Transport Note: 75 Shakespeare Avenue, Hayes, UB4 0BE

London Borough of Hillingdon, Planning Ref: 35060/APP/2026/132

Hillingdon Council Memo Dated 15th March 2026

Proposed Layout Plan

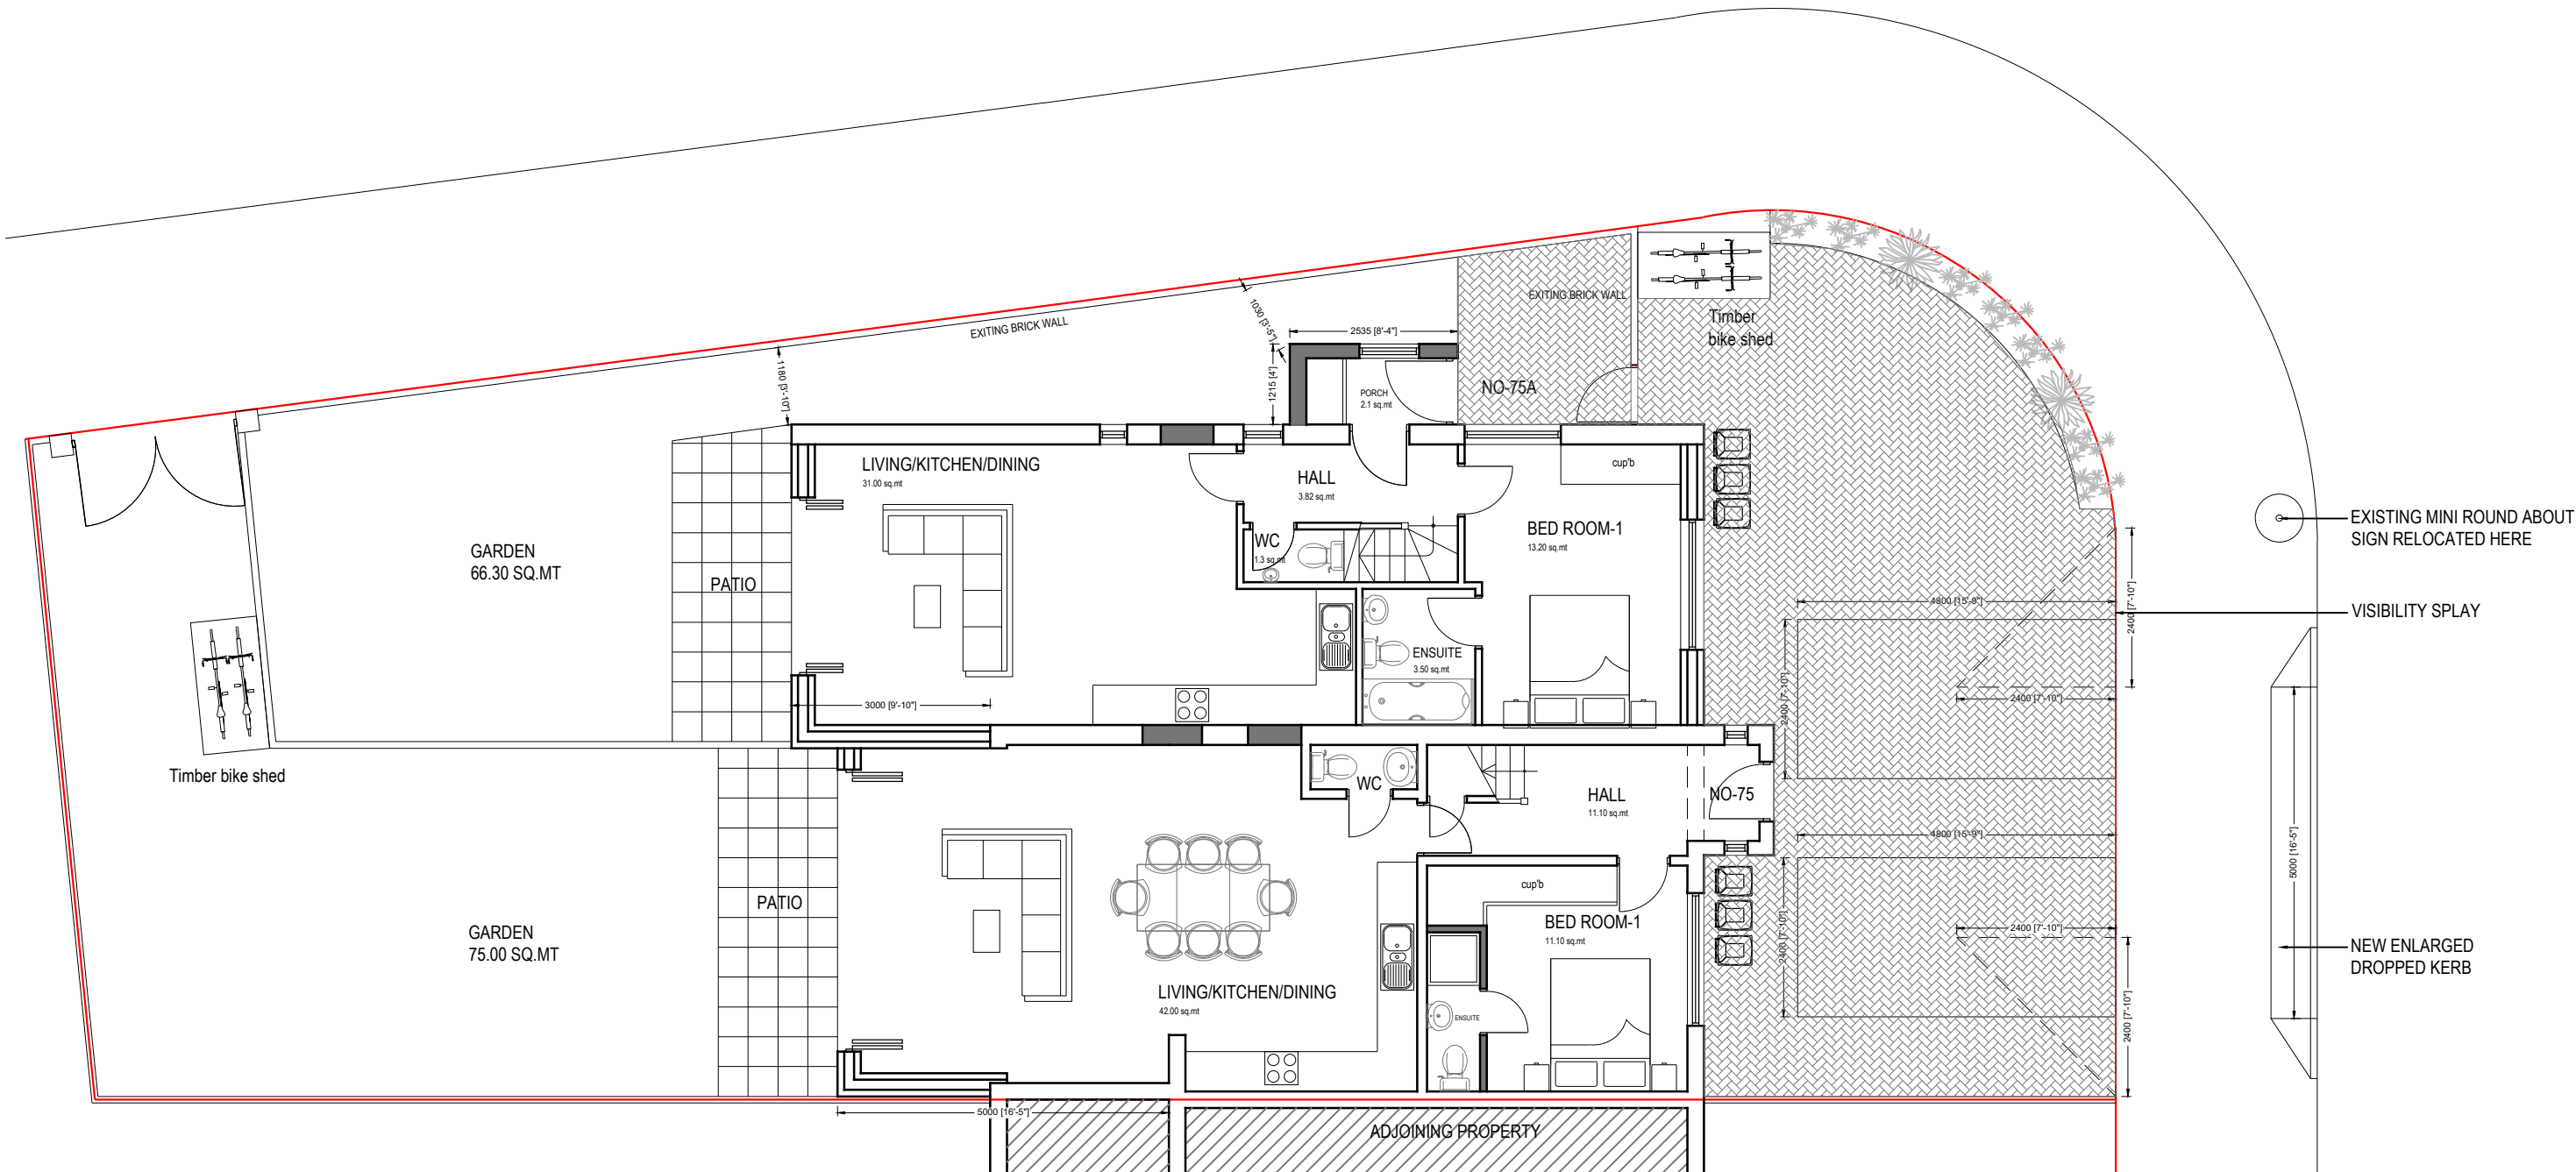
1. Unsafe and impractical shared access arrangement

The applicant proposes three parking spaces within a very constrained forecourt, served by a widened shared dropped kerb. However:

- Vehicles serving the new dwelling would need to cross into the donor dwelling’s red-line area to manoeuvre.
- Vehicles would need to drive over the splayed section of the dropped kerb, which is not designed for vehicle overrun, and may result in illegal footway overrun under the Highways Act.
- This creates operational conflict and an unacceptable risk to pedestrians.

2. Absence of required pedestrian visibility splays

Any new or widened vehicle access must provide 2.4m × 2.4m pedestrian visibility splays, as required by Manual for Streets, supported by Local Plan Policy DMT1, and reinforced within the Council’s Domestic Vehicle Footway Crossover Policy.

No visibility splays are shown on the submitted drawings.

3. Donor dwelling pedestrian access obstructed

The two side-by-side parking spaces for the donor dwelling obstruct the pedestrian entrance and the route from the front door to the public highway.

4. Cycle storage remains inaccessible

The cycle shed for the new dwelling cannot be accessed safely or conveniently due to insufficient standing/turning space in front of it.

11. The proposal will close one of the existing crossovers into the site from Balmoral Drive, retaining and extending the existing crossover on Shakespeare Avenue. There will be two parking spaces.
12. The proposal with two spaces removes the issues associated with the parking layout and pedestrian access concerns that were raised in the memo on the previous proposal. Pedestrian intervisibility splays are shown on the plan contained in Appendix F.
13. A legal agreement will be in place to confirm rights of access to the driveway to allow vehicles associated with either dwelling the ability to cross the red line boundary of either dwelling.
14. The cycle store will be turned around to ensure access can be appropriately achieved.
